Bringing back the birds

RE: <http://www.regulations.gov> Docket No. FWS–R1–ES–2018–0095; Draft Environmental Impact Statement ([DEIS](#)) and Draft Habitat Conservation Plan ([DHCP](#), with [appendices](#)); Receipt of an Application for an Incidental Take Permit (ITP) for Marbled Murrelets, Bald Eagles, and Golden Eagles; Skookumchuck Wind Energy Project, Lewis and Thurston Counties, Washington

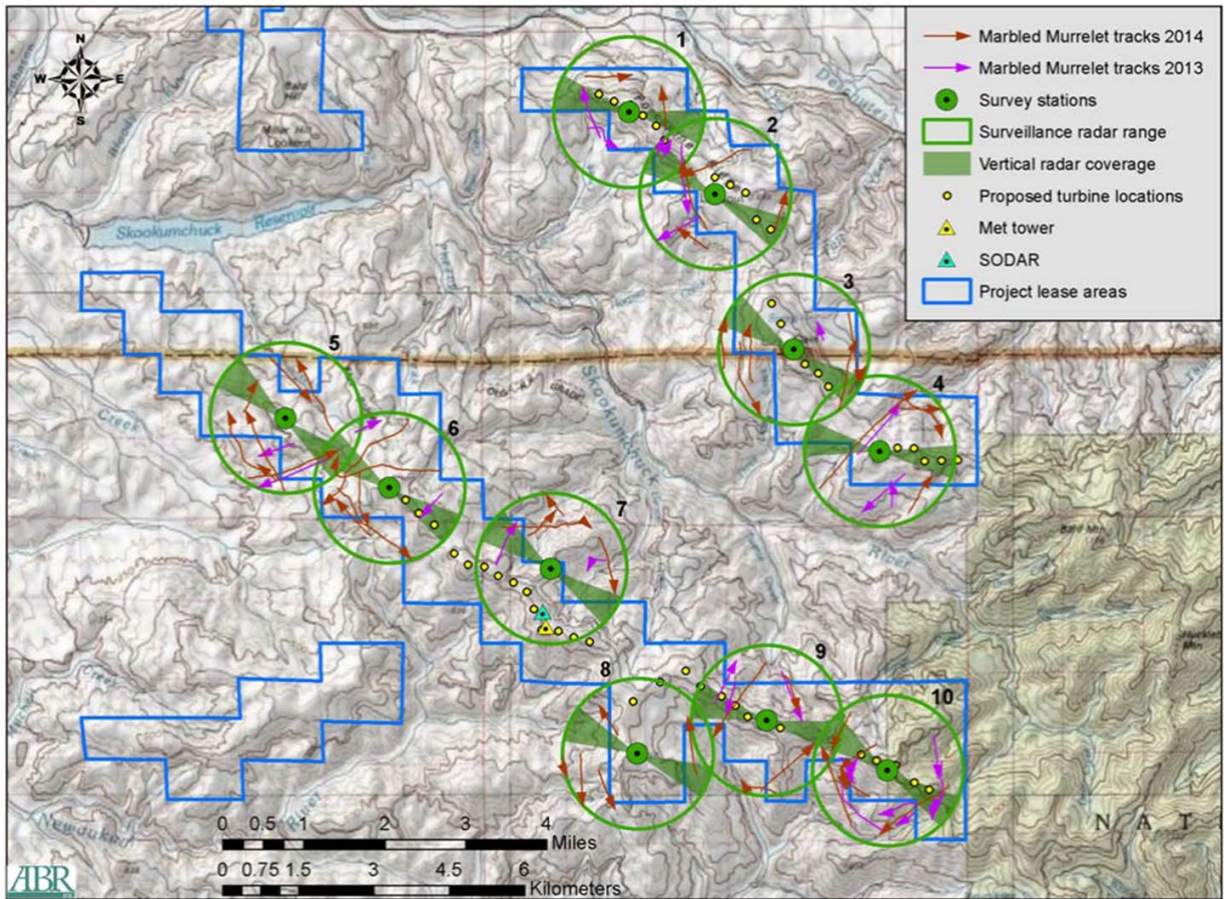
Alternative 2 reduces the proposed take of Marbled Murrelets to 58 individuals, and effectively removes the 5 turbines (i.e., prohibits operation of T34-T38) closest to a cluster of known Marbled Murrelet nests (see map in Appendix 5 of the DHCP and Fig. 7 from Attachment A of the DHCP, copied below). The 5 turbines to be removed under Alternative 2 are in close proximity to Marbled Murrelet and Northern Spotted Owl critical habitat⁹ in the [Gifford Pinchot National Forest](#) (see ABC’s [Wind Risk Assessment Map](#)). Table 3.7-1 of the DEIS states that Northern Spotted Owls are not likely to be found in the study area, based on avian surveys. Alternative 2 is absolutely necessary to minimize murrelet mortality.

Unfortunately, crepuscular curtailment is not enough to minimize impacts to murrelets, particularly given the proposed DHCP compensation package. The dawn/dusk time window corresponds to flights of murrelets into the tree stands (landward), but adults return to sea (seaward) at other times during the day. Furthermore, while feeding their chicks, adults fly back and forth at all times of day (Hamer and Nelson 1995¹⁰). Therefore, full curtailment during the breeding season (during all hours of the day and night) should be mandatory for all sites with Marbled Murrelets (i.e. all turbines, based on Fig. 7).

Fig. 7 from Attachment A of the DHCP (p. 14). “Map showing the flight paths of Marbled Murrelet radar targets heading in landward and seaward directions observed before sunrise at each of ten radar sampling stations at the proposed Skookumchuck Wind Energy Project, Lewis and Thurston counties, Washington.” Under Alternative 3, the 5 turbines to be removed (T34-T38) would be the ones in the bottom right, near radar survey station 10, where there is a cluster of known murrelets in critical habitat near the Gifford Pinchot National Forest.

American Bird Conservancy recommends the No Action alternative under the given scenarios in the DEIS and DHCP. The proposed take under the given Alternatives is too high, particularly given the suggested compensation package. However, we would be willing to consider a re-analysis of the proposed minimization, mitigation, and compensation measures, with a conservative combination of Alternatives 2 and 3: remove the 5 southeast turbines and implement full curtailment during the murrelet breeding season.
